Memo

Re: 144 Addison Street – Supplemental Information

Addison Street Partners, LLC is submitting the enclosed Supplemental Information related to the proposed multi-family residential project located at 144 Addison Street (the "Project") is in response to feedback provided by the City of Boston and the neighborhood. Our team filed an Expanded PNF with the City of Boston on January 19th, 2018 and a Scoping Determination was issued on May 18th, 2018. We filed a DPIR with the City on August 13th, 2018 in response to additional City agency and community comments.

East Boston, Massachusetts
Figure 7
Perspectives Comparison

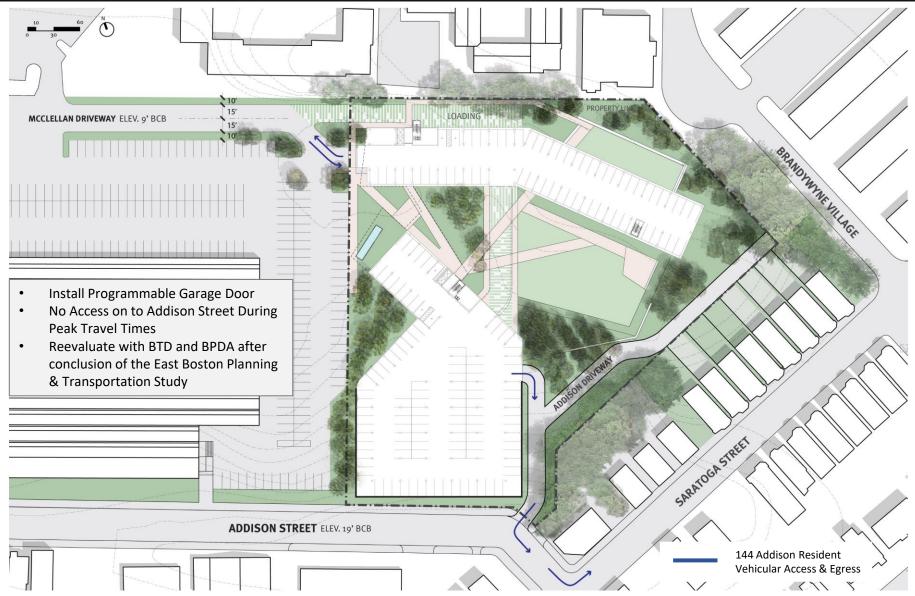
In addition to the unit count, some of the directly abutting Saratoga Street neighbors expressed privacy concerns due to the height and proximity of the building on the Project Site's north side (the "North Building") to their homes. In response to this concern, our team presented 2 design alternatives to the neighbors to obtain feedback on their preferred massing approach. One alternative proposed the 20-unit reduction as a 'straight cut' along the full height of the northeast corner of the North Building, and the second alternative proposed the same unit reduction through a stepped-back terraced approach. The neighbors confirmed their preference for the stepped-back terraced approach. We have revised our proposal to include this preferred massing approach. Please refer to the enclosed *Figures 1 – 7* reflecting the density and massing change.
